PORTLAND GENERAL ELECTRIC COMPANY

Trojan Nuclear Plant  
Docket 50-344  
License NPF-1

RESPONSE TO

NUCLEAR REGULATORY COMMISSION

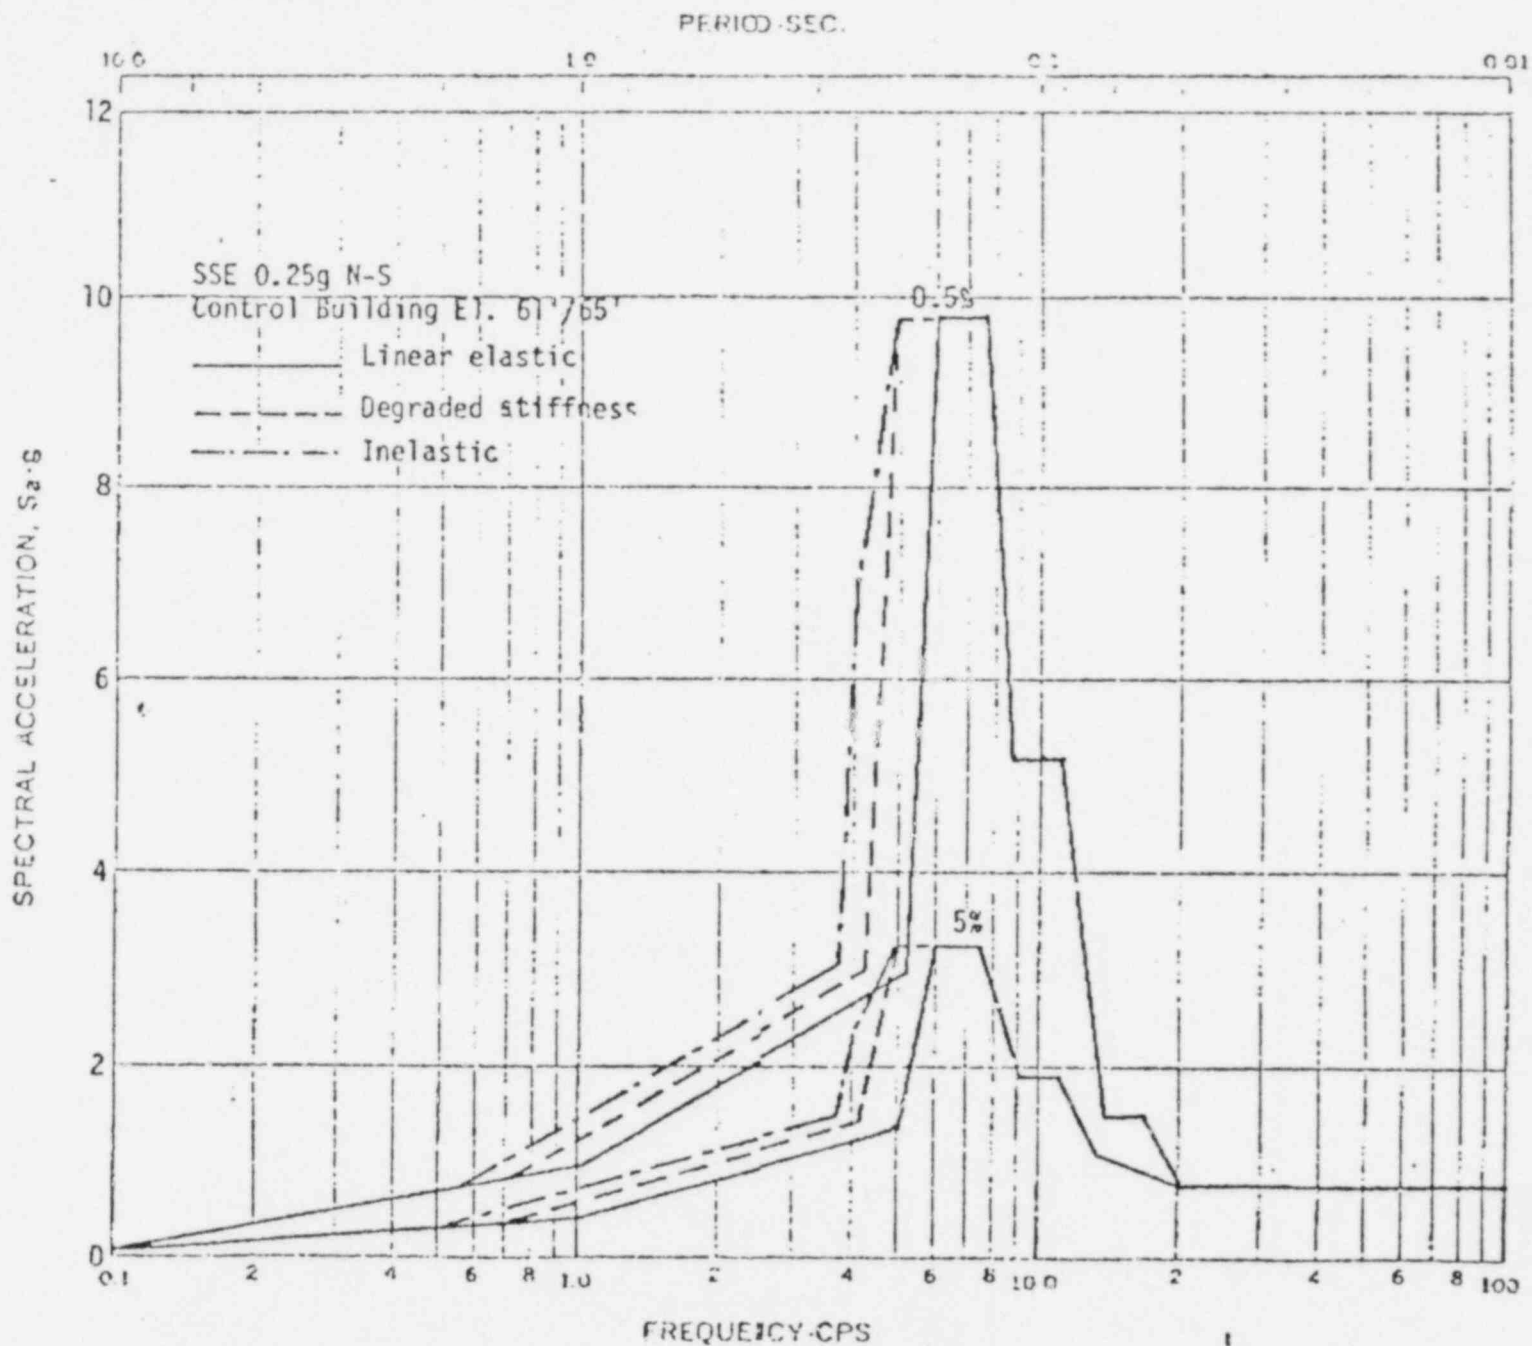
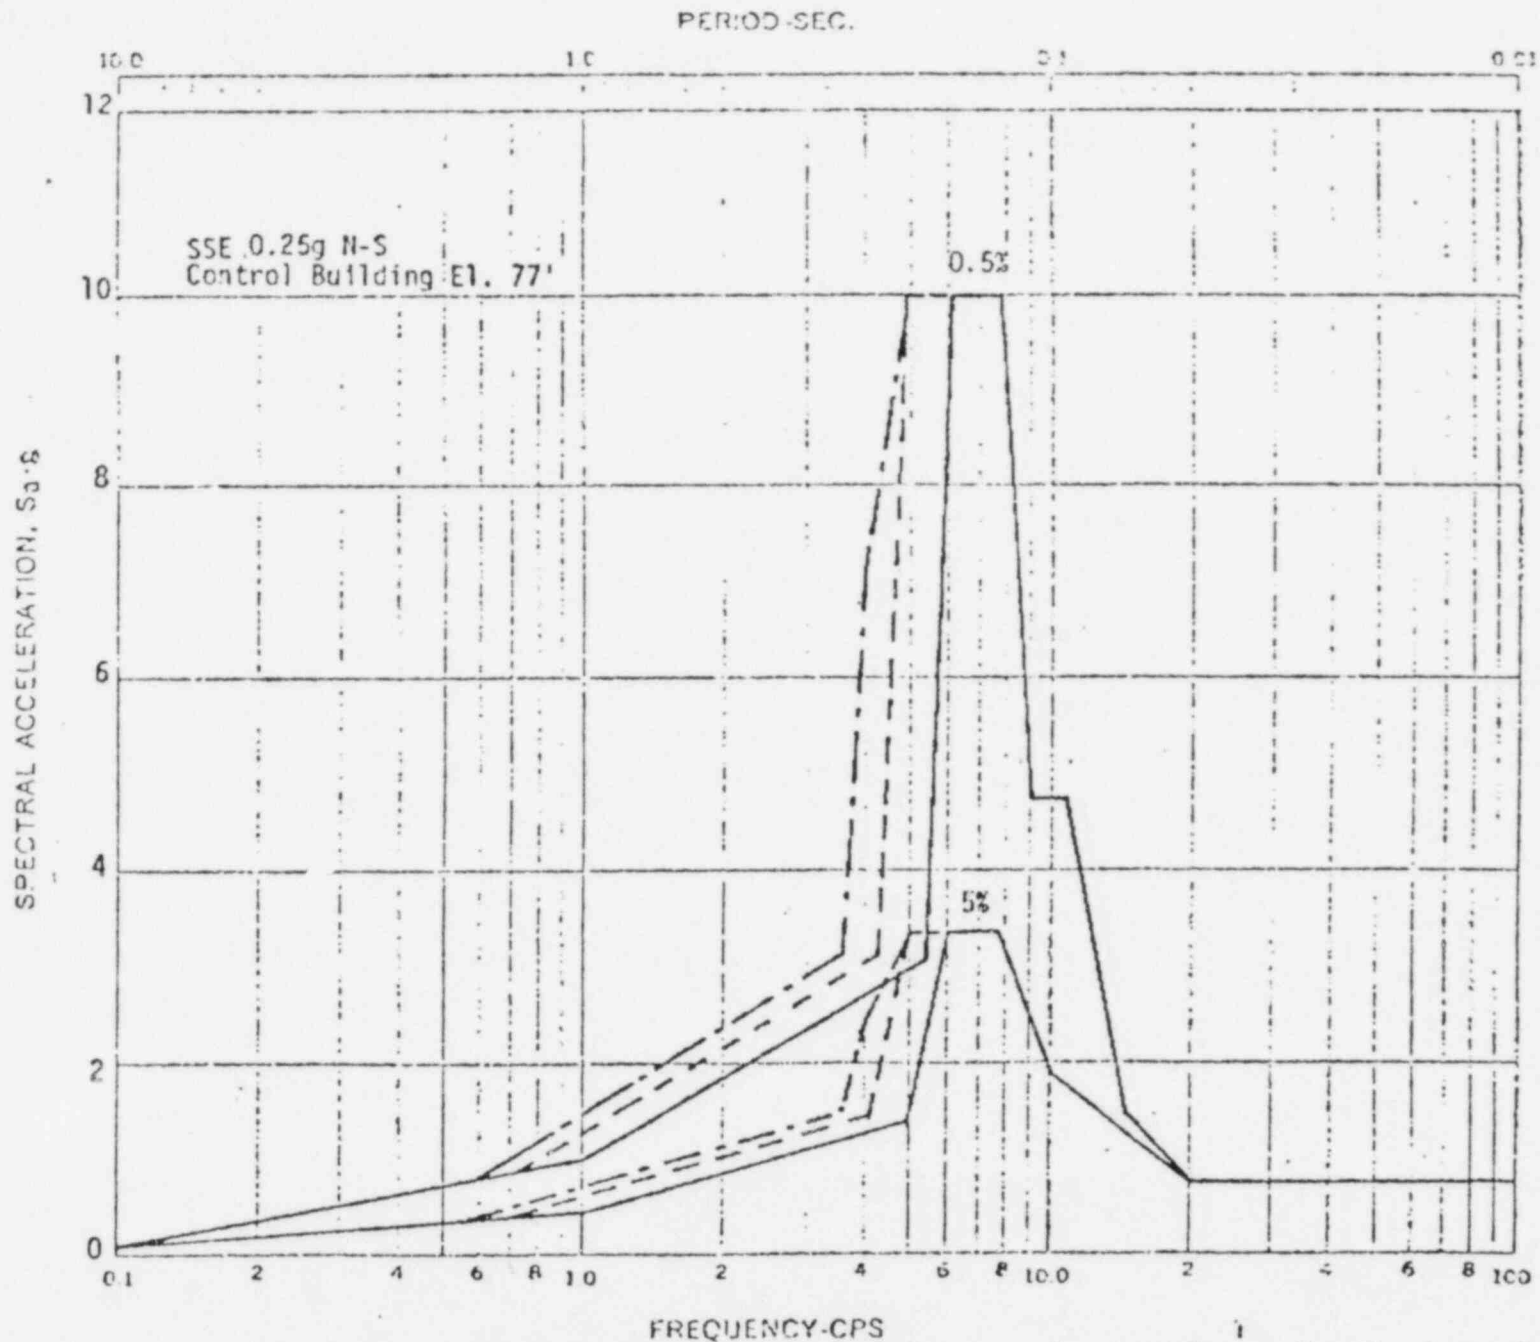
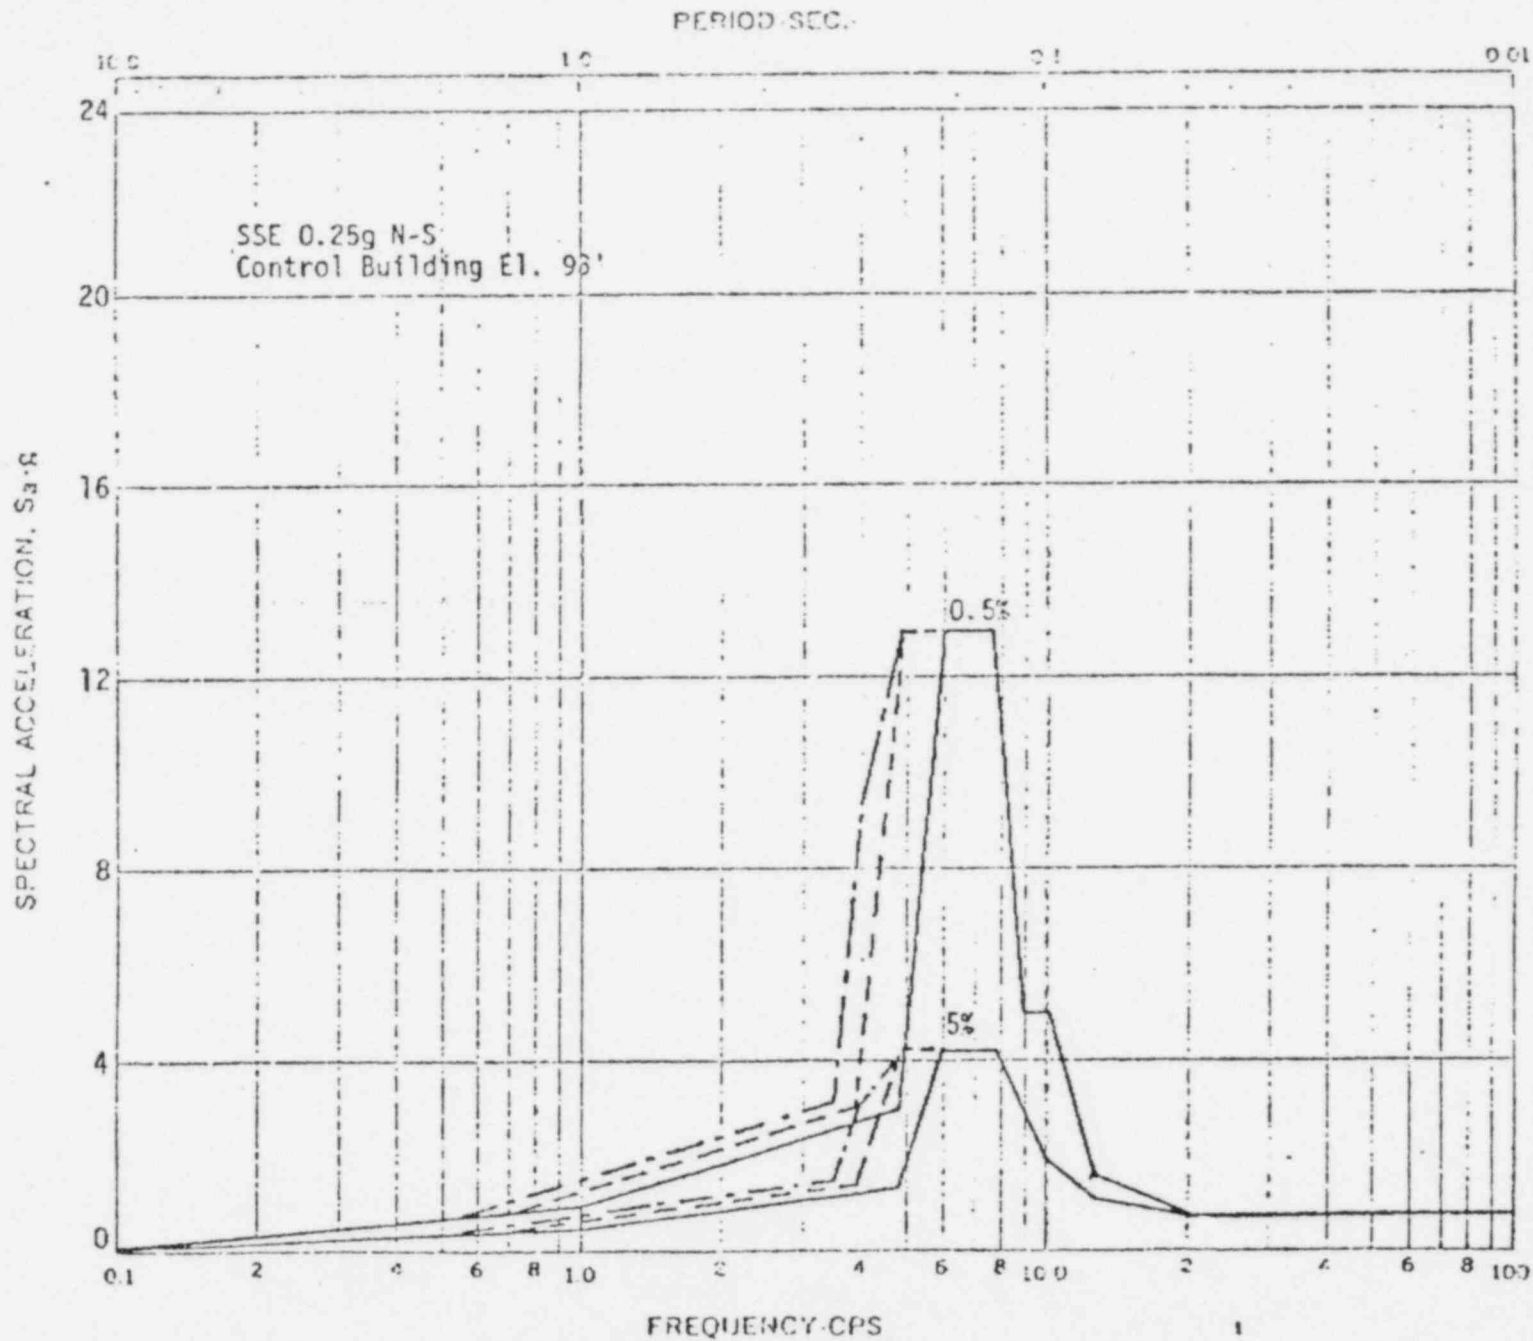
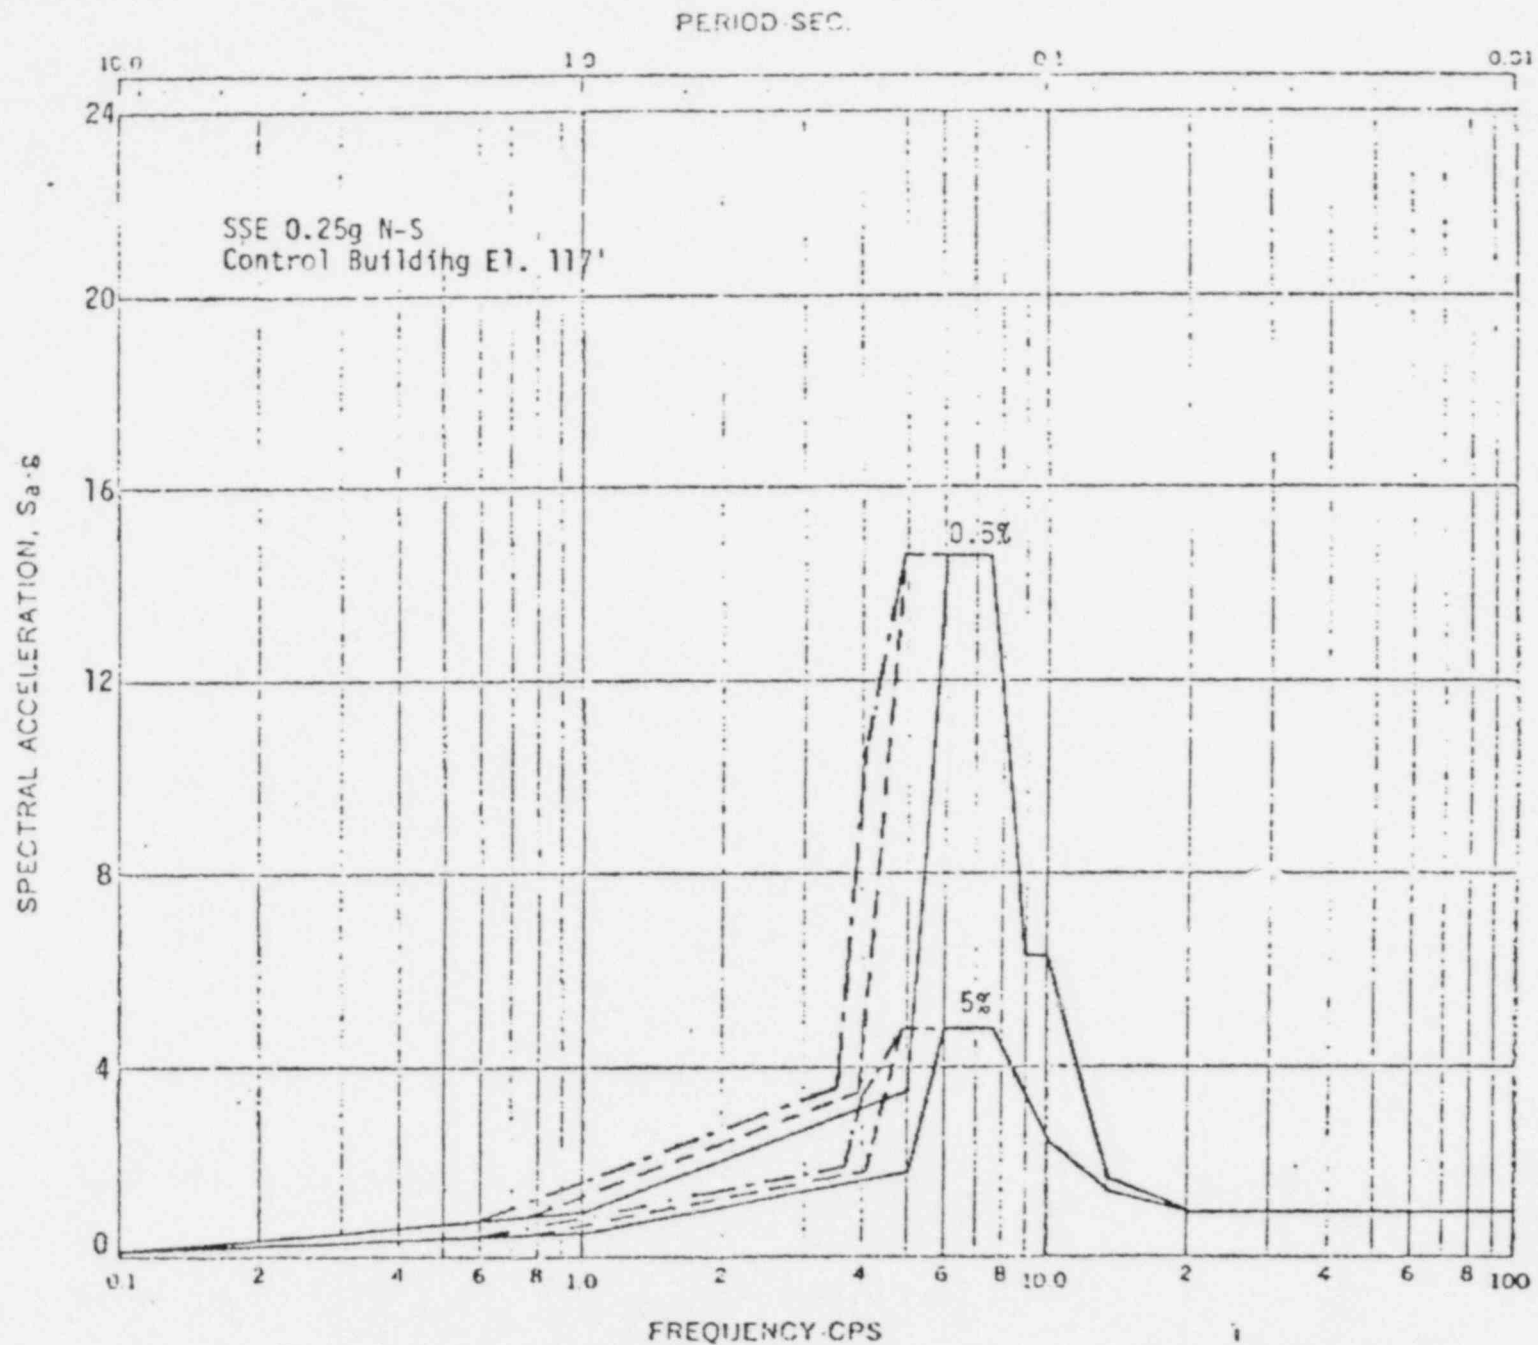
Delineate and quantify the various factors (e.g. mass and material property variations) considered in the development of the response spectrum peak broadening criteria for the linear, the degraded stiffness, and the nonlinear (those considering ductility) curves to verify their adequacy to account for any uncertainties in the analytical procedures. Also, rather than the "steps" in the spectra considering the frequency shifts due to ductility, the transition should be gradual between the frequency corresponding to zero ductility and the frequency corresponding to a ductility of 1.5. Therefore, consider this and indicate the impact on your analyses. Additionally, consider the effects of the Control Building's ductility on the Auxiliary and the Fuel Building responses.

The steps in the Control Building N-S floor response spectra shown in broken lines correspond to the upper bound ductility ratio of  $\mu = 1.5$ . If the ductility ratio is assumed to vary between 1.0 and the upper bound value of 1.5, the following reduction factors in spectral peak frequency and peak magnitude result:

Using the above factors, Figures 11 through 14 of the October 27, 1978 submittal can be re-plotted. The resulting spectra are shown in Figures 4-1 through 4-4. These revised response spectra have no impact on the results of analyses.

Figure 5-1 Qualitative Definition Of SECANT Modulus

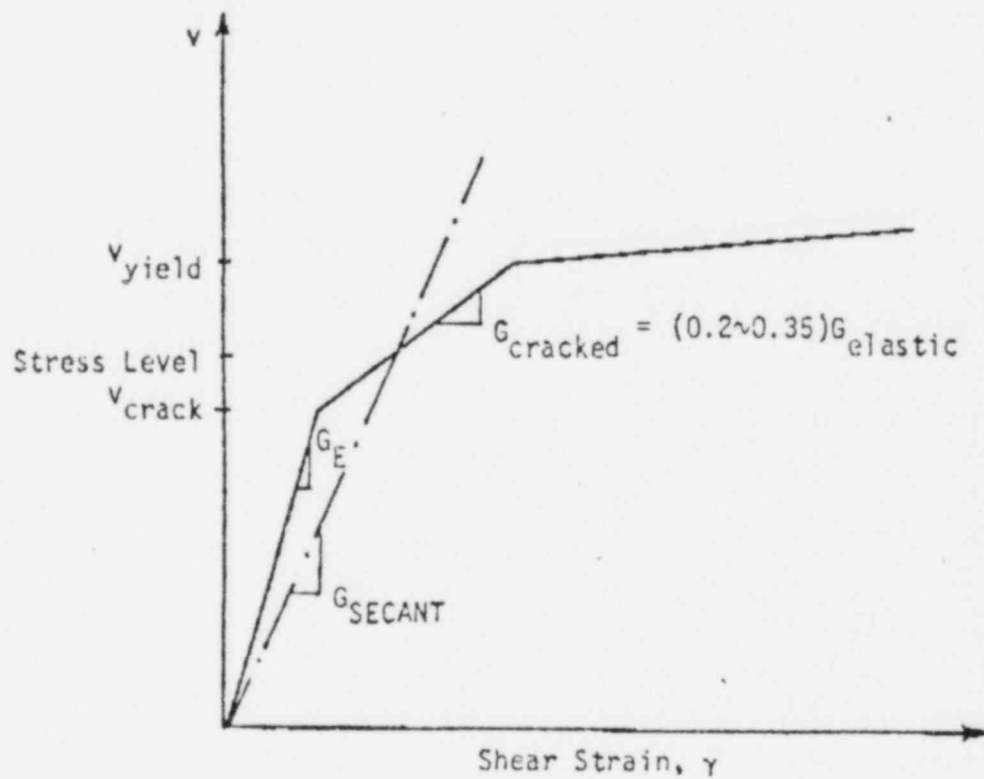
State the moduli of elasticity and the Poisson's ratios for the various floor slabs and wall types in the linear elastic STARDYNE analyses and provide your bases for these properties. Also, provide justification for the stiffness degradation factors reported in Table 4 (i.e., provide the relationships between stiffness degradation vs load for the various floor slabs and wall types corresponding to their location in the building complex) considered, and the bases for these relationships.

For the quasi-nonlinear analysis performed, the stresses that result from the analysis are the maximum stresses the walls experience during a very short duration of the response to a time history of an earthquake. Therefore, the reduced stiffness used in the analysis is the SECANT modulus as against the instantaneous stiffness. This is shown qualitatively in Figure 5-1.
